# ISSUE DOCUMENTATION – RTCA SC-186

Short Title for Change Issue:	Display of position uncertainty, $R_{NAC}$
-------------------------------	--

**Figure 1: Indicating Position Uncertainty on a CDTI Display.**

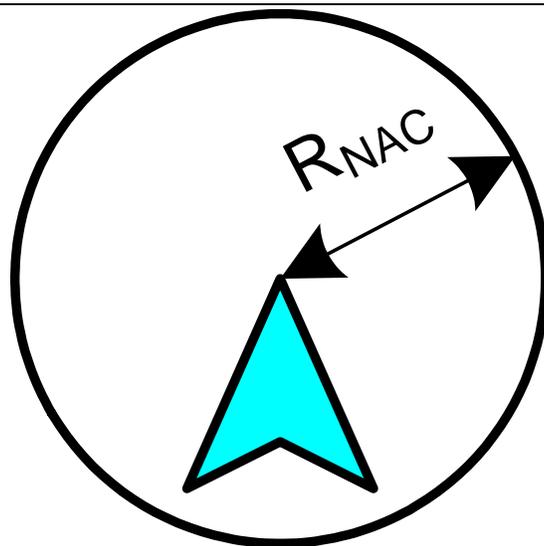
Nature of Issue:	<input type="checkbox"/> Editorial	<input type="checkbox"/> Clarity	<input type="checkbox"/> Performance	<input type="checkbox"/> Functional
Issue Description (attach additional sheets if necessary):				
<p>It has been proposed to <i>require</i> that all traffic targets for which the <math>NAC_P</math> code is too small (e.g., <math>NAC_P &lt; 5</math>, EPU or HFOM <math>\geq 1</math> NM) <i>must</i> be removed from the CDTI display.</p> <p>I would like to relax this proposed requirement, so as to permit an alternative, as described below.</p>

If  $R_{NAC}$ , the maximum EPU (Estimated Position Uncertainty) for a traffic target's the NAC code, is large compared to the symbol for that target on the CDTI display, the uncertainty in target position might be represented by a circle with center at the reported position of that target.

Originator's proposed resolution if any (attach additional sheets if necessary):
<p>For traffic targets with non-zero <math>NAC_P</math> codes, permit the CDTI display to show the target's position uncertainty. One way to do this might be to draw a circle with radius <math>R_{NAC}</math> around the target, where <math>R_{NAC}</math> is the least upper bound on the EPU value for the <math>NAC_P</math> being reported by that target. <u>Figure 1</u> shows how this might be done.</p>
